**Monitoring Year 3 FINAL Monitoring Report**  
**Stewarts Creek Tributaries Stream Restoration Project**  
**Surry County, North Carolina**  
**Yadkin River Basin, Hydrologic Unit Code (HUC) 03040101**

**RE: Response to Draft Monitoring Year 3 report for the Stewarts Creek Tributaries site Yadkin River Basin – CU# 03040101 – Surry County DMS Project ID No. 100023. Contract # 7183**

**RE: Response to Draft Adaptive Management Plan Comments dated May 26, 2022  
Stewarts Creek Tributaries Stream Restoration Project  
Yadkin River Basin –HUC 03040101 – Surry County, North Carolina  
NCDMS Project # 100023, Contract # 7183**

FIGURE 1B

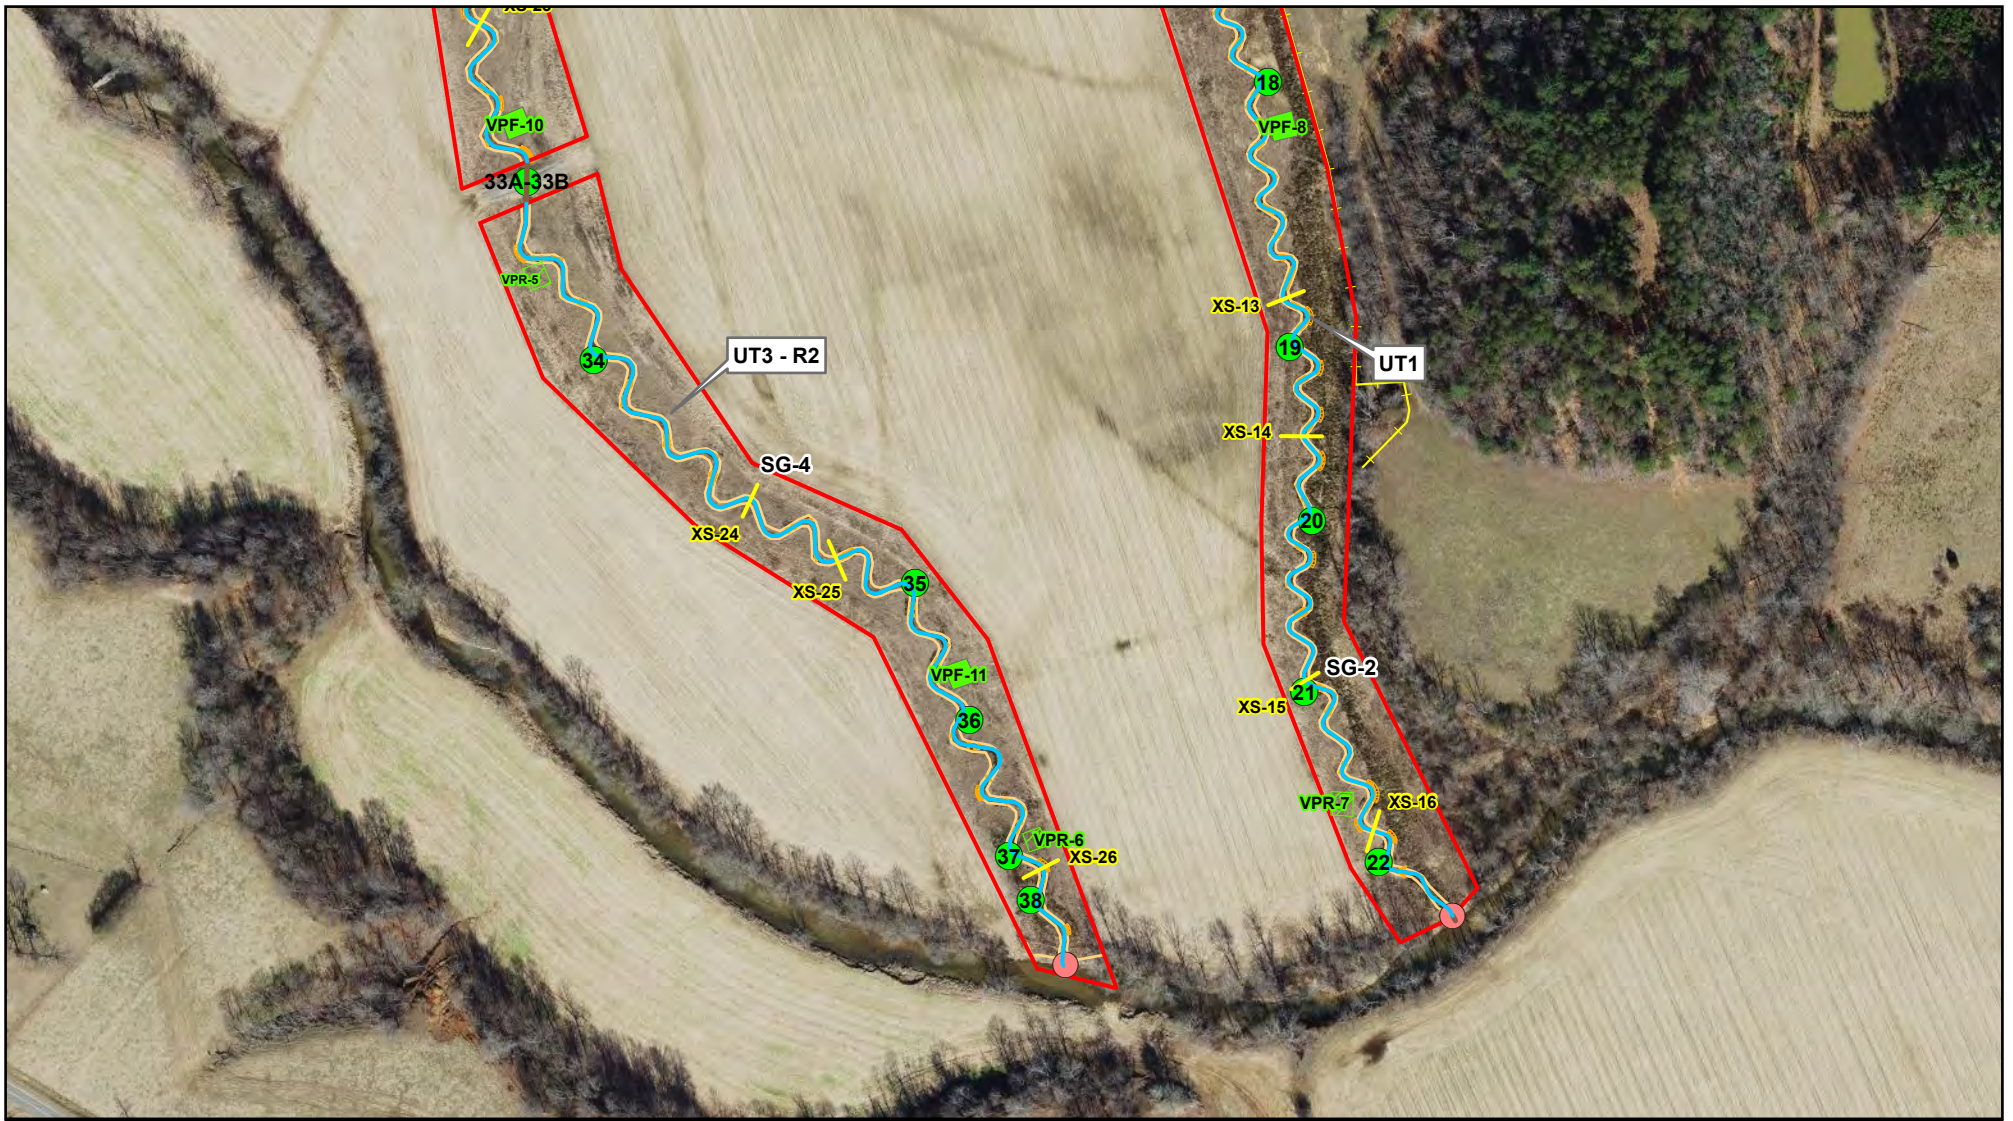
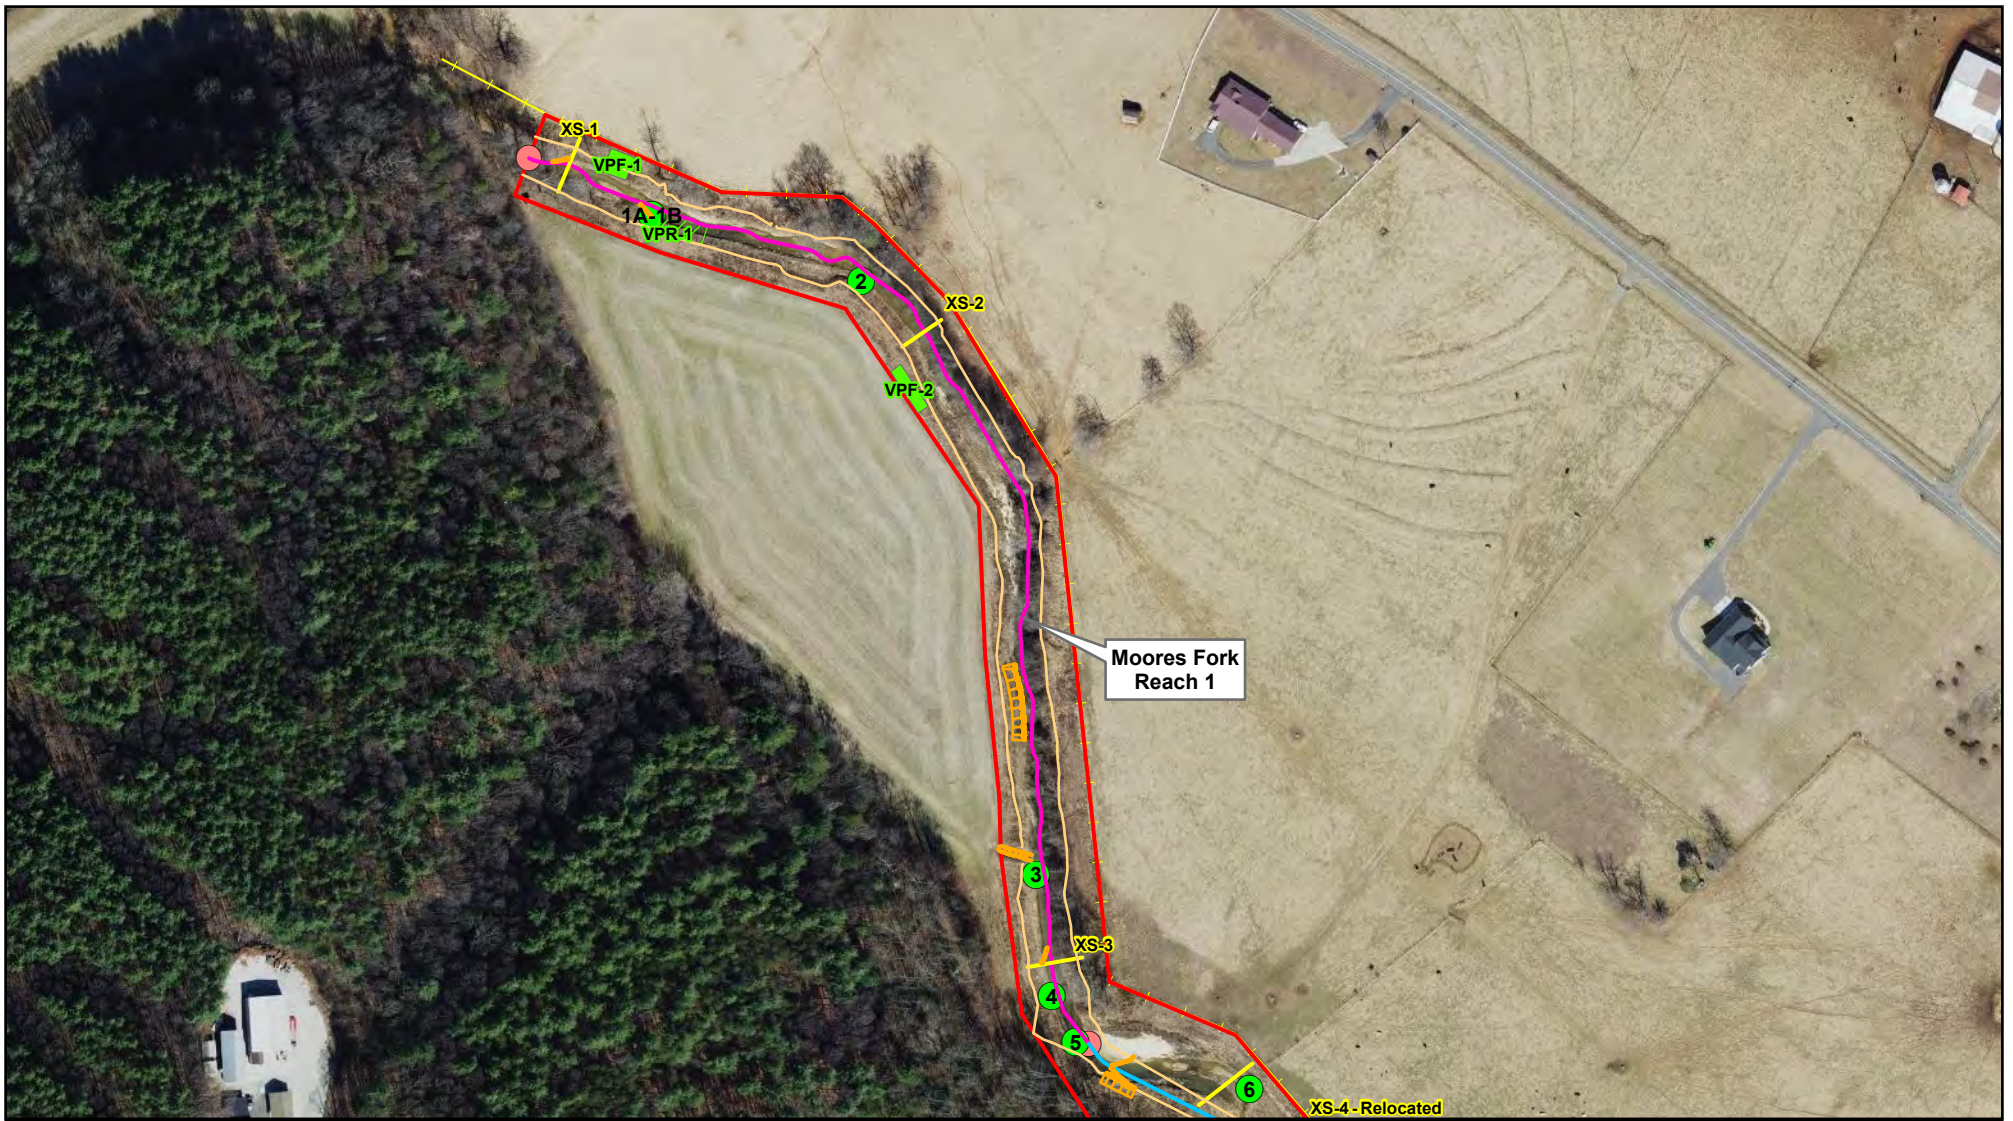
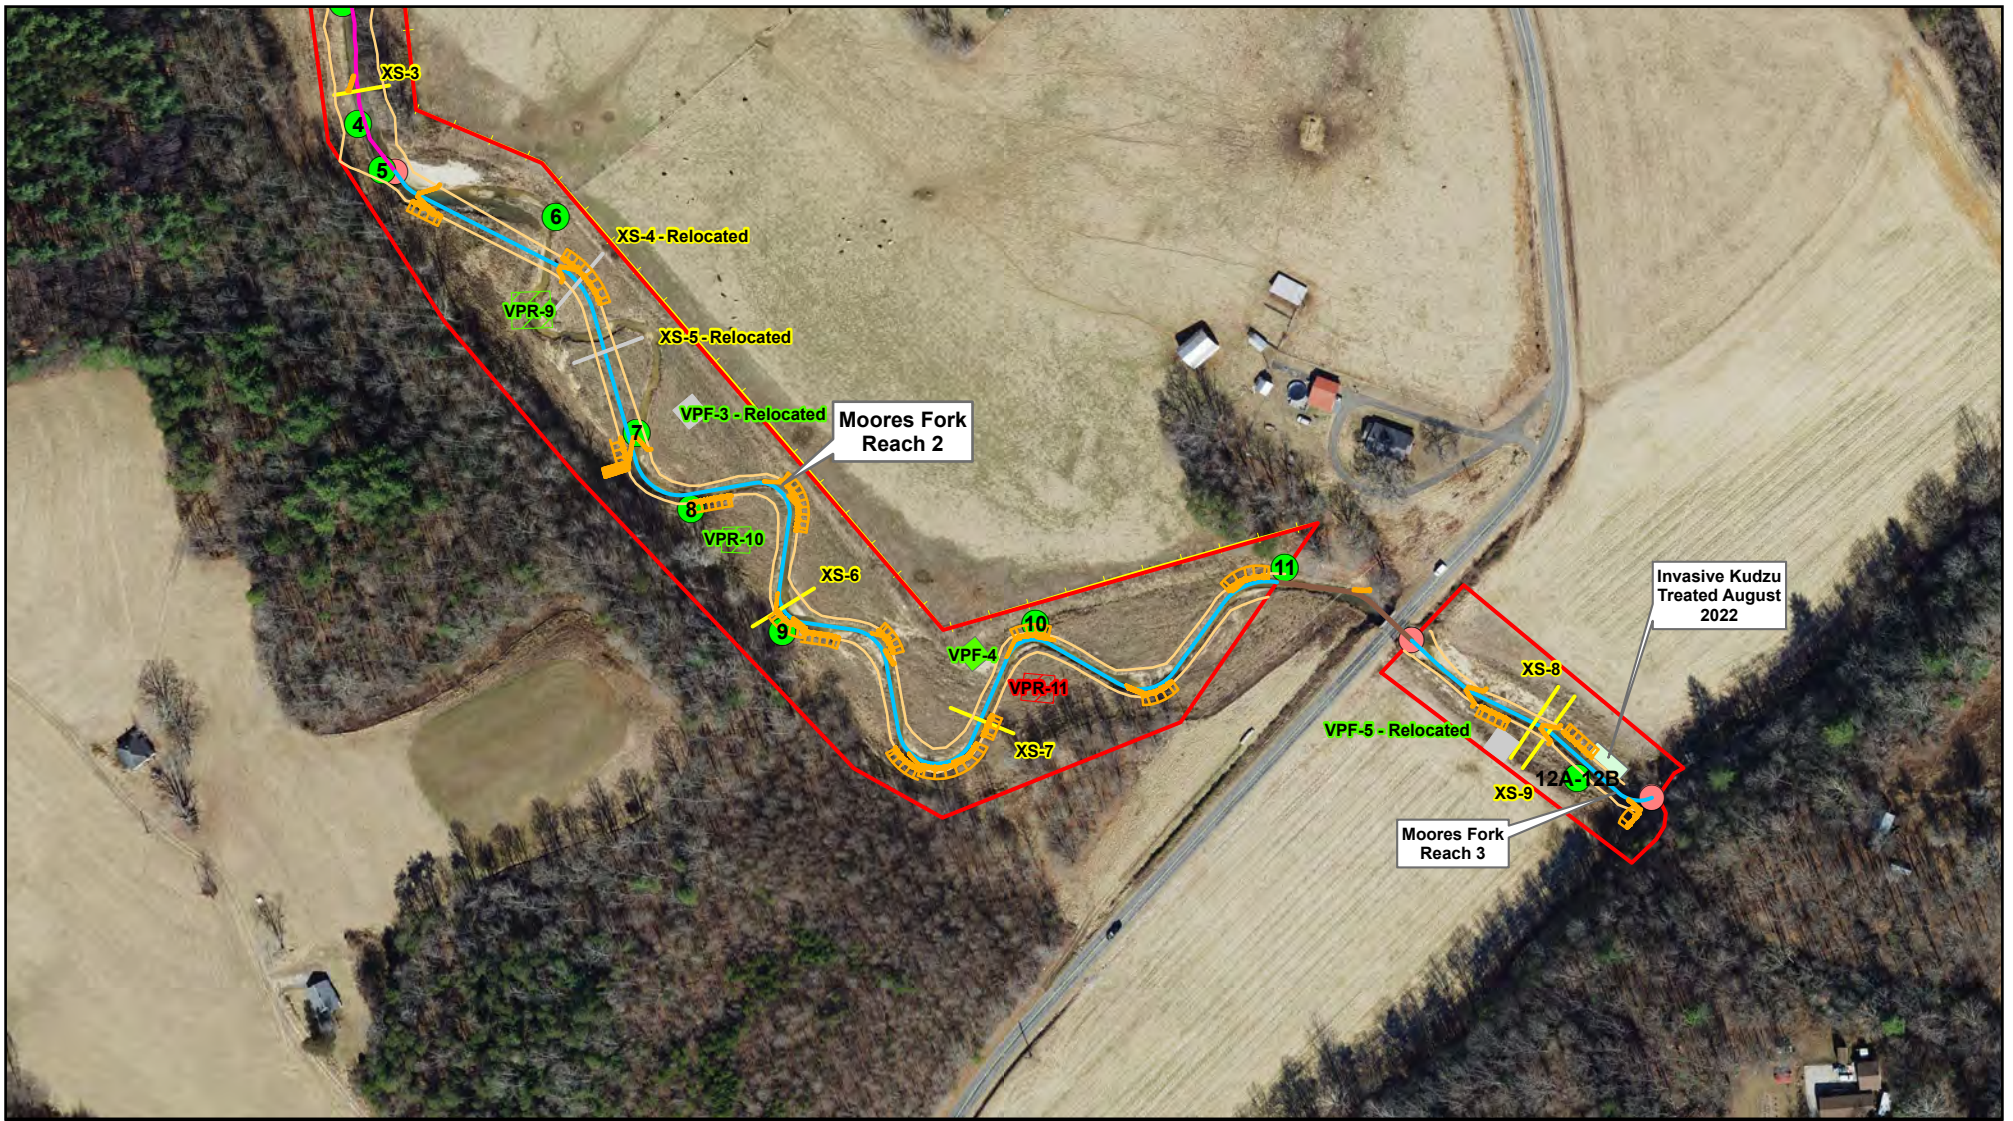
- *The Flow Data Summary Table across all years of monitoring is missing from the submission. Please include it in the final digital submission.*
  - **Included in digital submission.**
- *EPR identified .1 acres of invasives which is the mapping threshold for spatial data. Please submit the spatial file for the area of invasives listed on the vegetation visual assessment table and show the area on the report's final CCPV map.*
  - **The 0.1 acres was the area of invasive kudzu that was treated in August 2022. It was included on the table to note that the area will be continually treated to prevent the kudzu from spreading as stated in Section 2.2.1. This area and note are included on the final CCPV map and digital support files.**
